# TOWN OF HAYMARKET PLANNING COMMISSION

1. Site Plan Review: 14600 Washington Street - QBE - ZP#2017-02

**Re: QBE Business Park  
 Preliminary/Final Site Plan**

**Comment Letter dated February 13, 2017 (Holly Montague):**

### COVER SHEET

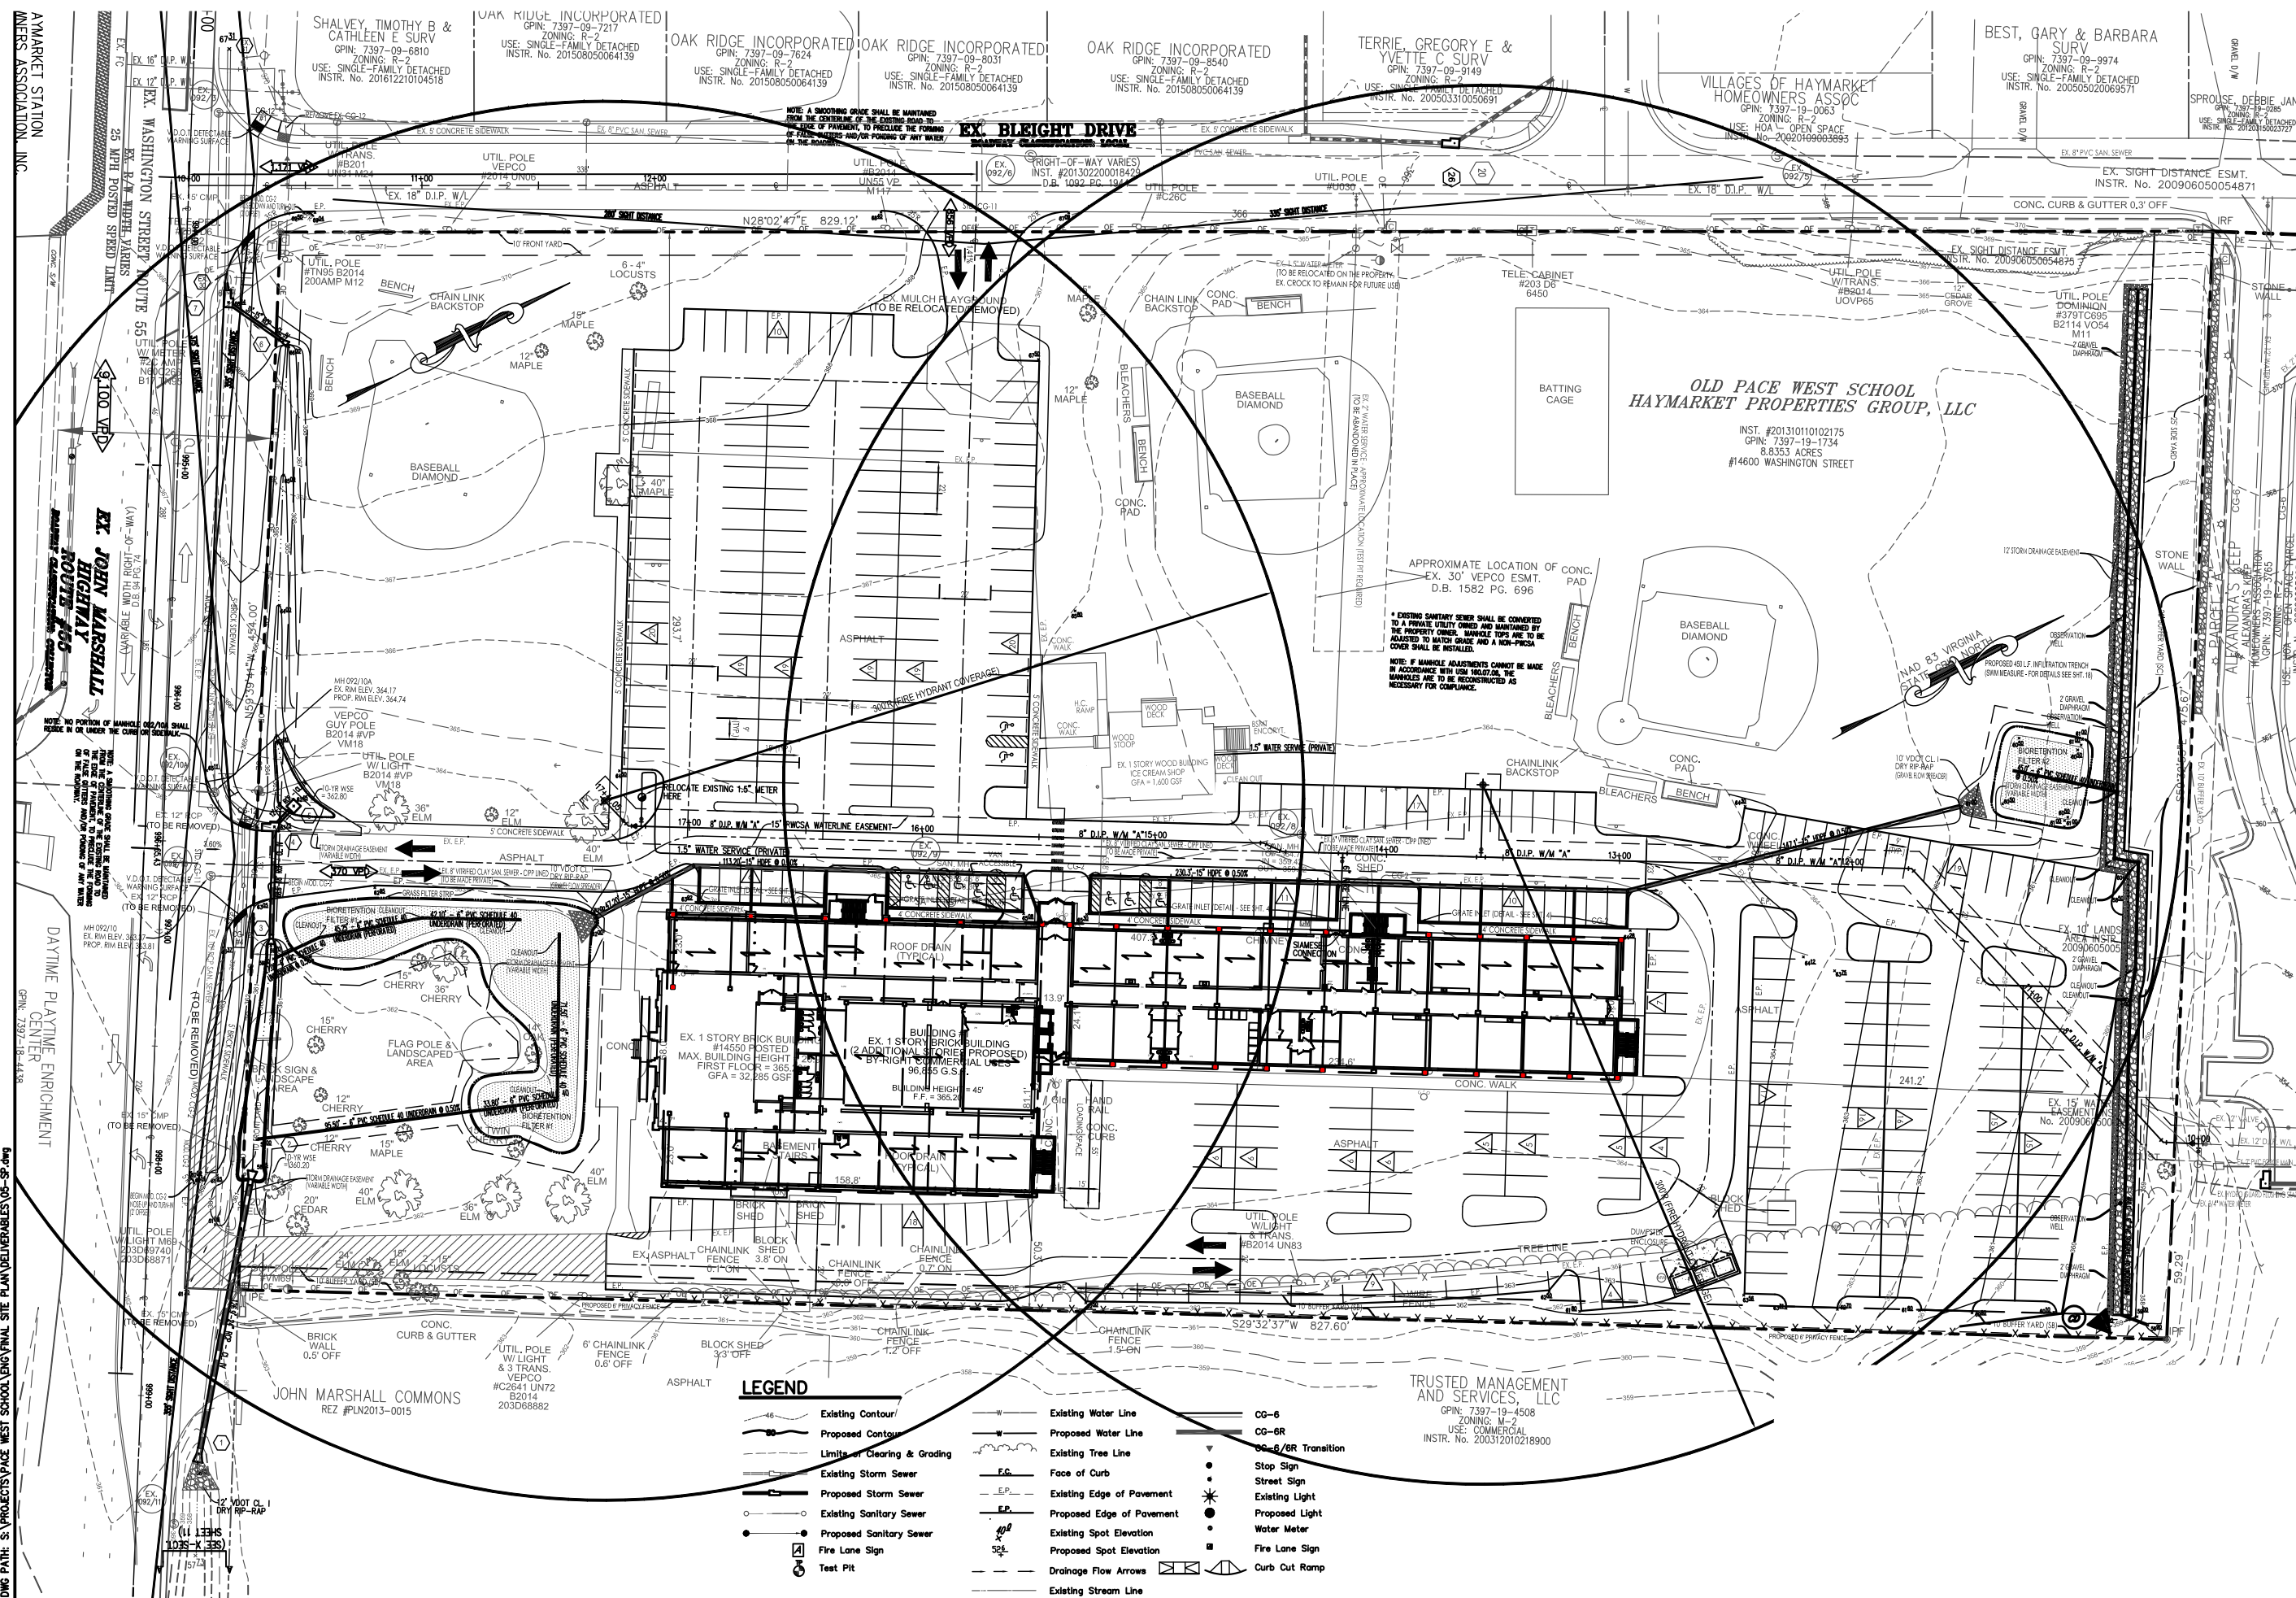
| 5. | <b>Checklist</b><br>2)d. and 3)d. | <ul style="list-style-type: none"> <li>a) State all present uses of the site on the Cover Sheet in the informational block on the lower right where it says "Present Use and Zoning."</li> <li>b) State present use and zoning on all plan sheets for abutting properties.</li> <li>c) On all plan sheets, state the abutting rezoning project "John Marshall Commons" and Prince William County project number for the Trusted Management and Services, LLC property.</li> <li>d) Provide an informational sheet overlaying the John Marshall Commons project demonstrating coordination between the projects, especially on Washington Street. Alternatively, show the John Marshall Commons project and provide written documentation from the project owner that states they will modify their plan to tie into all Washington Street improvements proposed by this project.</li> </ul> |

| 21. | <b>MISC</b> | Fill in Rezoning number on bottom right of Cover Sheet where it says "Related Plans Tracking Numbers" |

- Response:**
- a. The present uses have been added on the cover sheet.
  - b. The present use and zoning information have been added to the adjacent owner labels on all affected plan sheets.
  - c. The John Marshall Commons rezoning application number has been labeled on all affected plan sheets.
  - d. The applicant will work with the adjacent owner to provide the proposed tie-in location for the Washington Street frontage improvements. However, the applicant will defer to the Town to coordinate with Prince William County to require off-site frontage improvements as part of the adjacent rezoning application.

**Response:** Based on a recent inquiry to the Town staff and the approved proffers (see sheet 24B), it does not appear that an application number was assigned to the related rezoning application.

SCALE: H) 1" = 30'  
 V) N/A  
 DATE: DECEMBER 2016  
 CHECKED:  
 DRAWN: JHD  
 FILE NO: SP-035-HW  
 SHEET NO. 5 OF 24

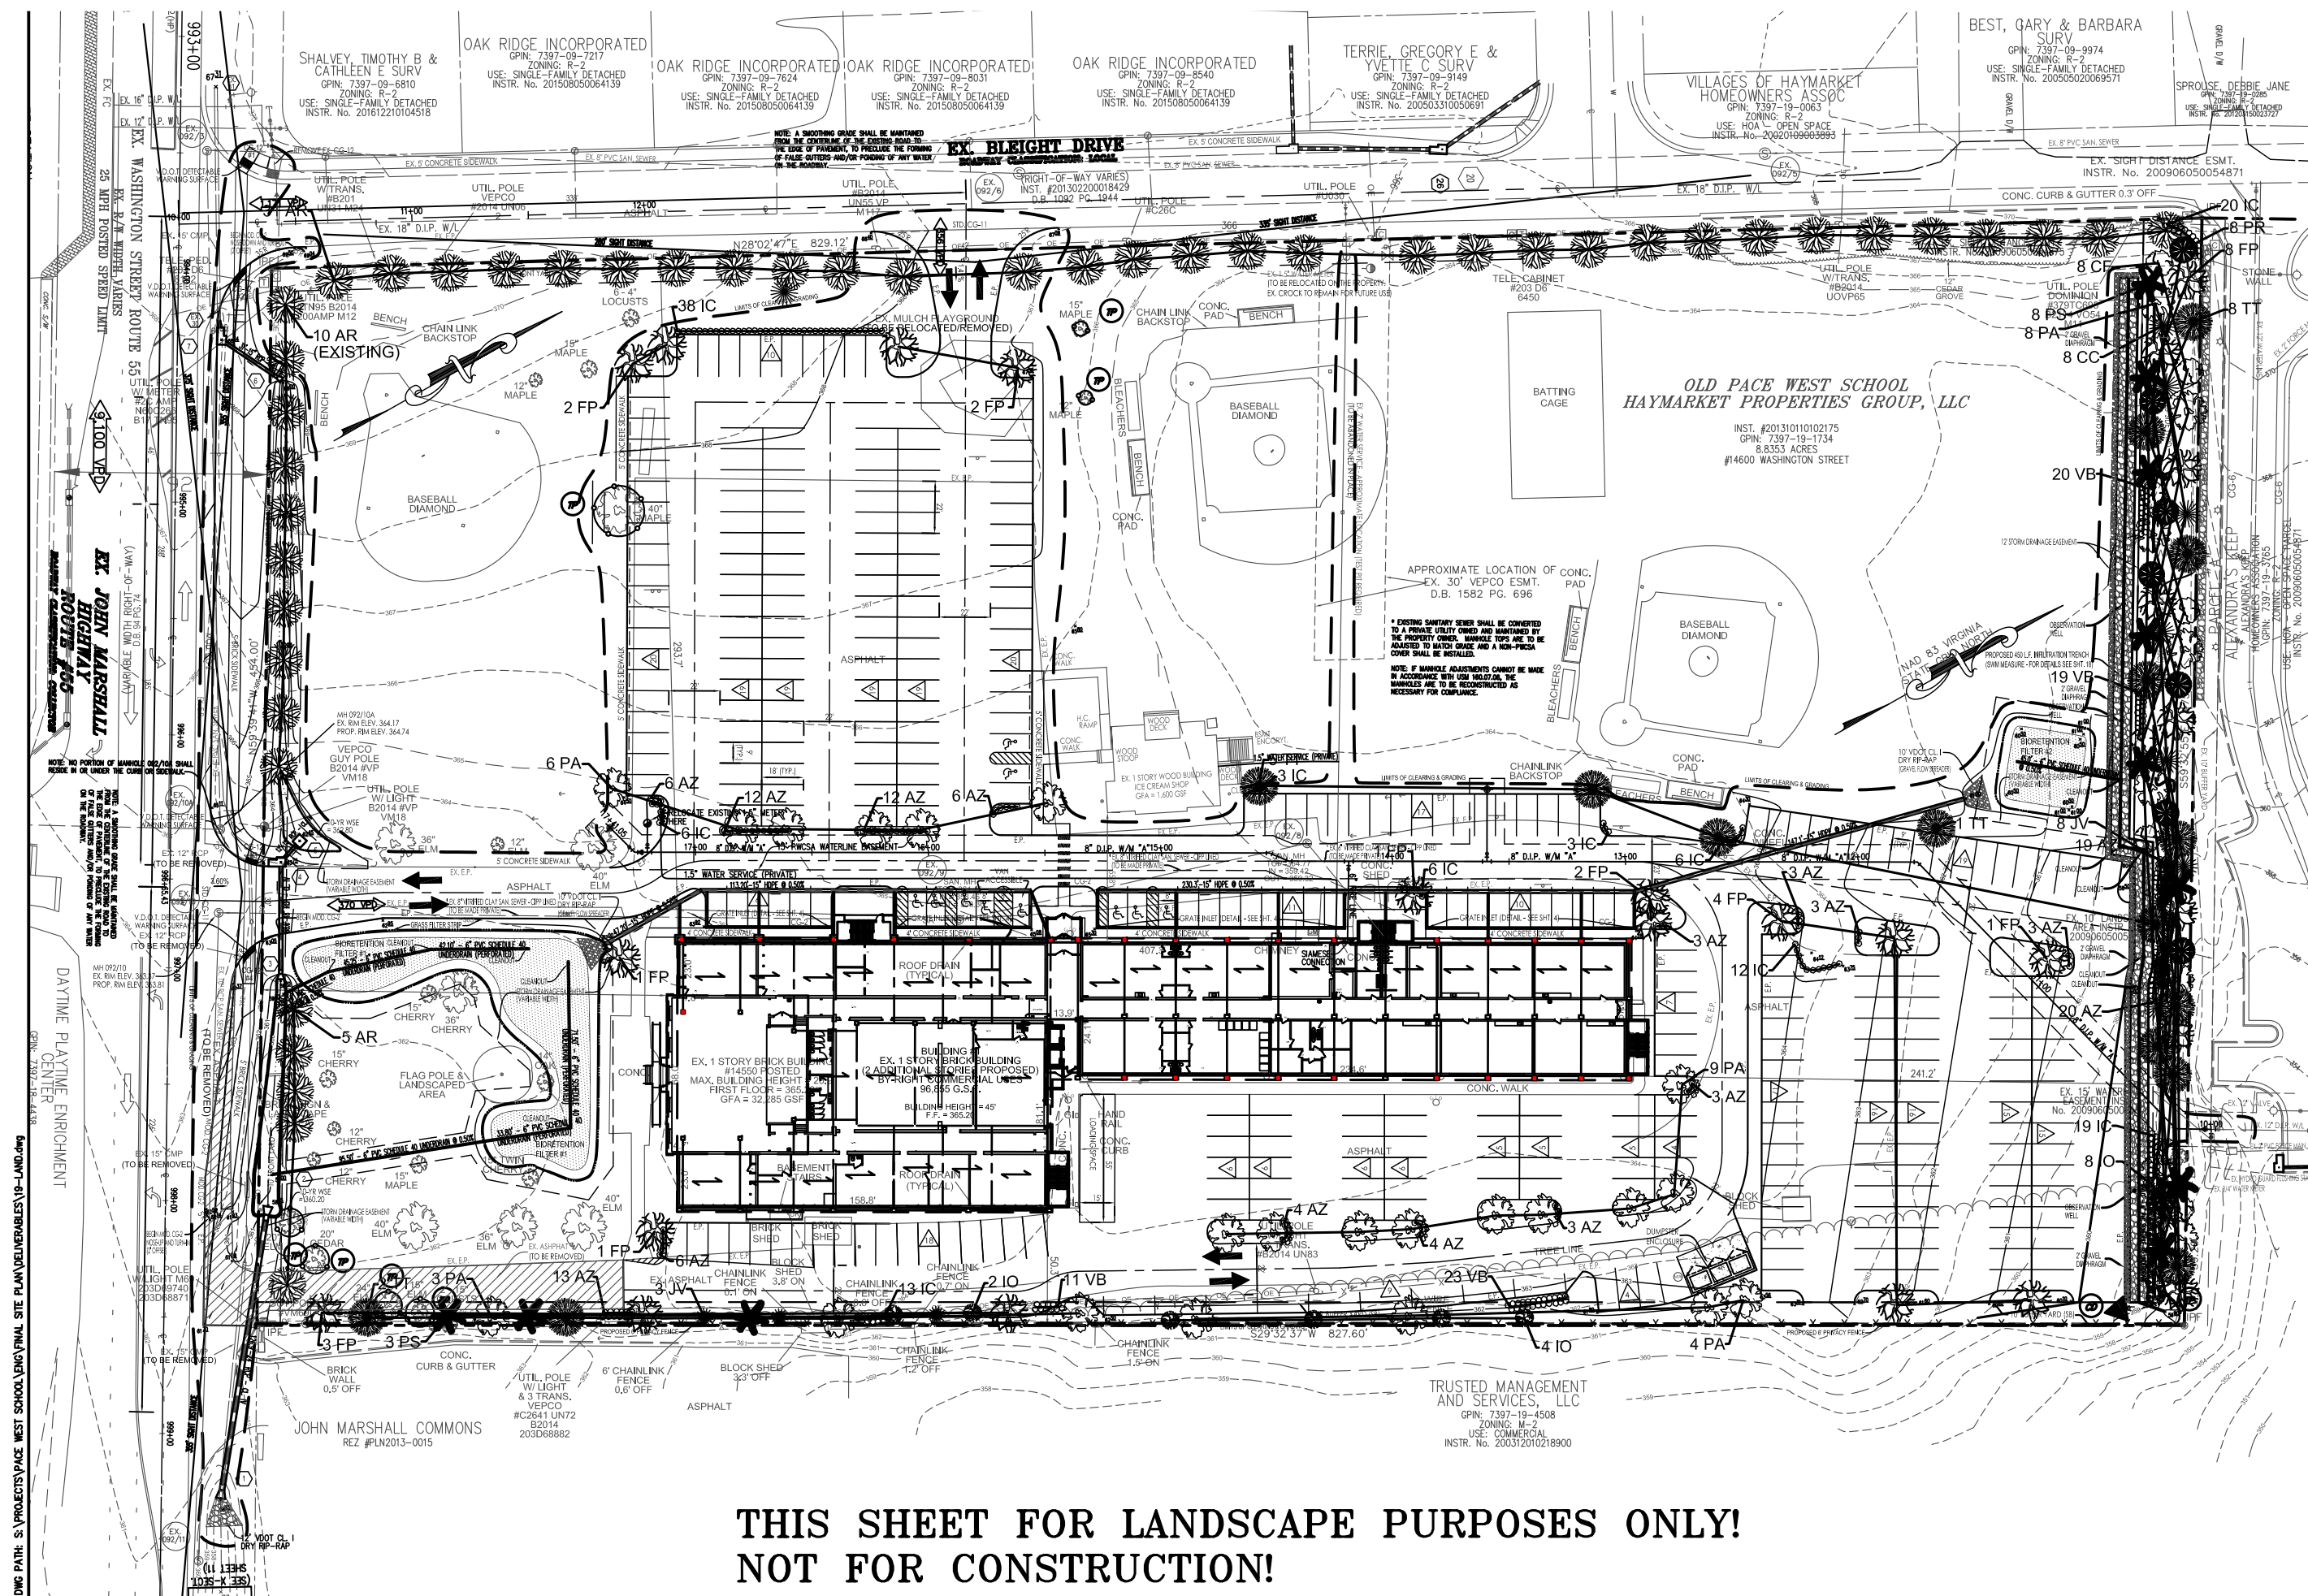
| 10. | <b>Checklist</b><br>2)j. and 3)m.<br>58-716 | <ol style="list-style-type: none"> <li>a) Show dumpster locations and associated screening in the plan view.</li> <li>b) State the proposed uses of all buildings.</li> <li>c) Show sidewalk on Bleight Drive (may be concrete).</li> <li>d) Revise Cover Sheet Supplemental General Note #9 to say concrete sidewalk in Right of Way will be maintained by VDOT and brick sidewalk in Right of Way will be maintained by Town.</li> <li>e) Show wheel stops when parking is head-in to sidewalk.</li> <li>f) Show distance from maintenance shed to two closest property lines.</li> <li>g) Show distance from ice cream shop to main building.</li> </ol> |

- Response:**
- a. Tproposed dumpster location has been shown on sheet 5. The dumpster enclosure detail and privacy screening detail have been provided on sheet 4.
  - b. The proposed uses of all buildings have been labeled in plan view on all affected plan sheets.

**LANDSCAPE PLAN**  
**OBE BUSINESS PARK**  
 SITE PLAN

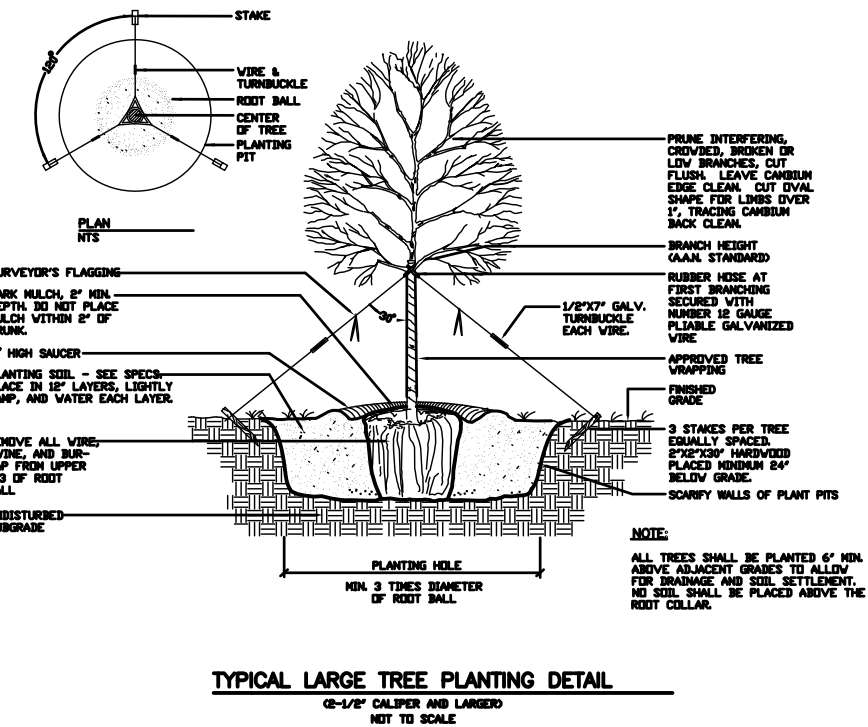
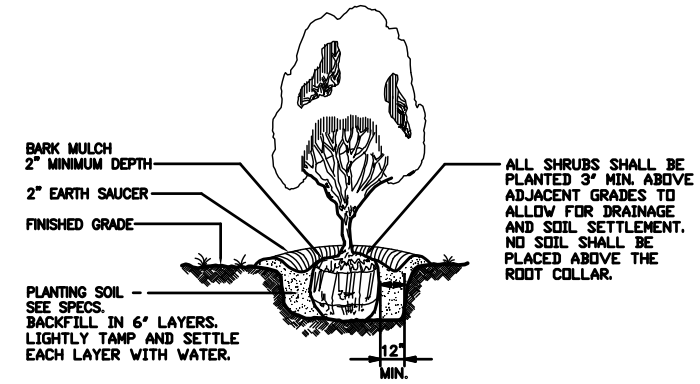
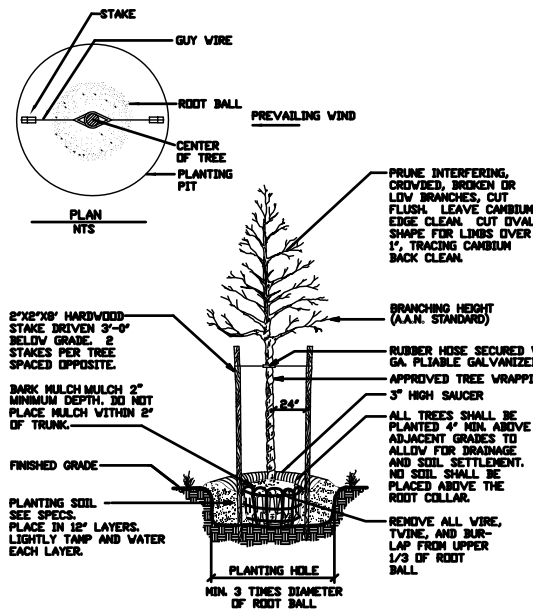
| 19. | <b>Checklist</b><br>2)w. and 3)aa<br>58-179(b)<br>58-700(3)<br>58-702<br>58-703(c)<br>58-703(e) | a) Remove Alexandra's Keep from Street Tree Calculations and create a buffer calculation for Alexandra's Keep with a 25' Opaque (SC) screen.<br>b) In Street Tree Calculations, state how the required plants are computed.<br>c) In Buffer Calculations, state the length of frontage used in the calculation.<br>d) Remove Buffer Calculation along western property line at Bleight Drive and add perimeter parking lot landscaping adjacent to Right of Way for the area the parking lot is close to Bleight Drive.<br>e) State the required (5%) and provided area for interior parking lot landscaping based on area of parking lot.<br>f) Verify the required interior parking lot landscaping trees and shrubs. The computations do not match the number of spaces provided on Sheet 3. |

- Response:**
- a. A 25' Type SC screen has been provided along Alexander's Keep in lieu of street tree calculations on the landscape plan on sheet 19. The landscape calculations have been revised accordingly on sheet 20.
  - b. The required tree spacing has been provided under Street Tree Calculations on sheet 20.
  - c. The proposed buffer lengths have been provided in the Landscape Calculations on sheet 20.
  - d. The proposed buffer along Ex. Bleight Drive has been removed and replaced with perimeter parking lot landscaping on sheet 19. The Landscape Calculations have been revised accordingly on sheet 20.
  - e. The required 5% of gross interior parking area calculation has been provided under Interior Parking Lot Landscaping Requirements on sheet 20.
  - f. The Interior Parking Lot Landscaping Requirements have been revised on sheet 20.
